**Petition for Post-Certification Modification  
Tanager Battery Energy Storage System Project**

**Data Response Set 3B**

**Los Esteros Critical Energy Facility  
03-AFC-02C**

**LOS ESTEROS CRITICAL ENERGY FACILITY (03-AFC-02C)**  
**Petition for Modification- Tanager BESS Project**  
**DATA RESPONSE SET 3B**

DRAWING NUMBER: **418008-00749-SK-SR-0001**

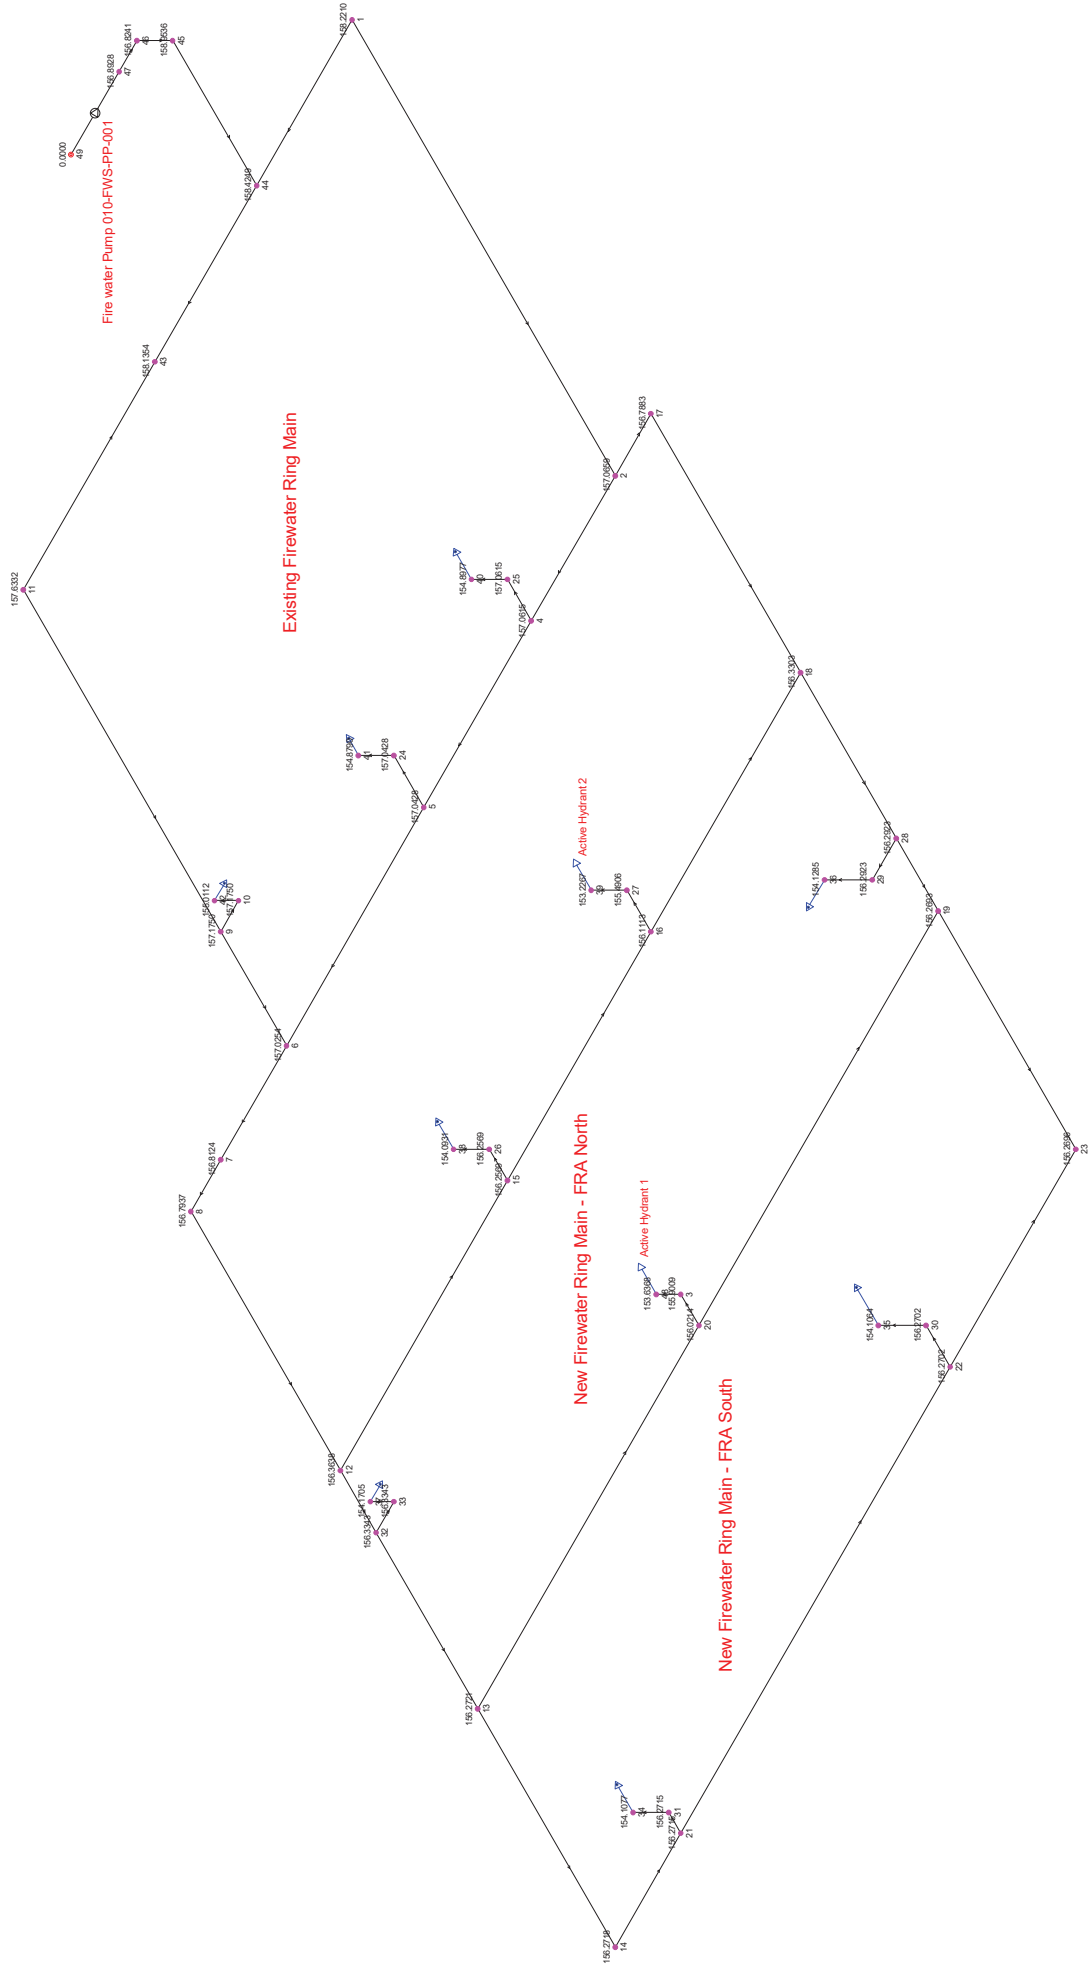
**A76.** *Please provide a schematic, equivalent to at least 30 percent design plans, and a complete description of the proposed fire protection systems for the proposed project, such as the fire water loop, fire water storage tanks, fire pumps, fire hydrants, etc.*

**RESPONSE:** The schematic of the fire loop and hydrant locations can be found in Attachment DR-A75, Appendix A.
